Access Compliance Report

Public Rights-of-Way

(Curb Ramps)

Intersection ID: 49273	Main Street: REMINISCE_LN	Cross Street: REUNION_ST	Location: NE
ADA ID: 6D8BD89B05AB	Ramp Type: BlendTrans1	Initial Pass/Fail: Fail	Overall Compliance: No
		Severity Score: 25

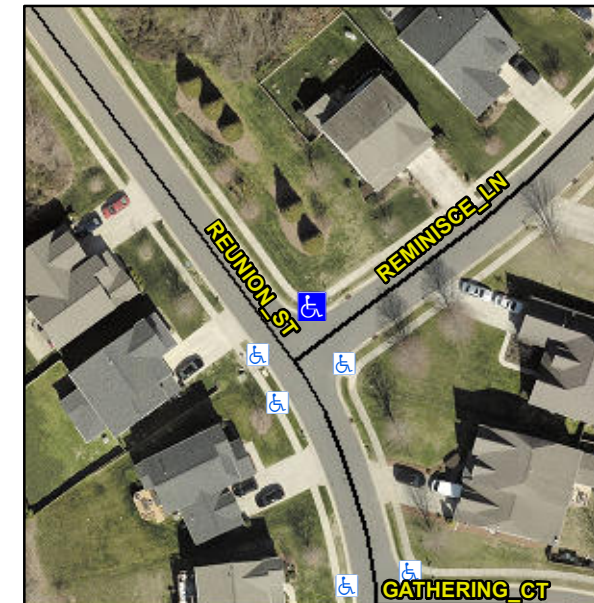
Not Found, R304.5.3

Compliance	Description	Data	Compliance	Description	Data
N/A	Ramp Length (in)	48.5	Yes	BlendTrans Slope (%)	4.1
Yes	Ramp Width (in)	48.0	No	BlendTrans XSlope (%)	11.0
N/A	Flare Type LT	N/A	N/A	Flare Type RT	N/A
N/A	Flare Slope LT (%)	N/A	N/A	Flare Slope RT (%)	N/A
N/A	Flare Traversable LT?	N/A	N/A	Flare Traversable RT?	N/A
N/A	Landing Length (in)	N/A	N/A	DWS Provided?	N/A
N/A	Landing Width (in)	N/A	N/A	DWS Contrast?	N/A
N/A	Landing Slope (%)	N/A	N/A	DWS Length (in)	N/A
N/A	Landing X Slope (%)	N/A	N/A	DWS Full Width?	N/A
N/A	Landing Curb? (Y/N)	N/A	N/A	DWS Offset (in)	N/A
N/A	Shared Landing?	N/A			
N/A	Gutter Ponding?	N/A	N/A	Gutter Slope (%)	N/A
N/A	Gutter Lip Ht (in)	N/A	N/A	Gutter X Slope (%)	N/A
N/A	Painted X Walk1?	No	N/A	Painted X Walk2?	No
	X Walk 1 Direction	To SW		X Walk 2 Direction	To SE
	X Walk 1 Width (in)	N/A		X Walk 2 Width (in)	N/A
	X Walk 1 Slope (%)	5.0		X Walk 2 Slope (%)	2.1
	X Walk 1 X Slope (%)	6.9		X Walk 2 X Slope (%)	8.8

N/A	Ramp inside XWalk1?	N/A	N/A	Ramp inside XWalk2?	N/A
	Road Slope (%)	10.8		Clear Space?	N/A
	Road X Slope (%)	0.7	N/A	Clear Space to XWalk (in)	N/A
N/A	Any Obstructions?	N/A	N/A	Storm Grate/Utility Hazard?	N/A
	Obstruction Type			Storm Grate/Utility Type	
		N/A			N/A
			Yes	Surface Condition? (G/P)	Good
			No	Curb Slope (%)	6.5

Remove & Replace Curb Ramp With Two New Directional Ramps or Equivalent.
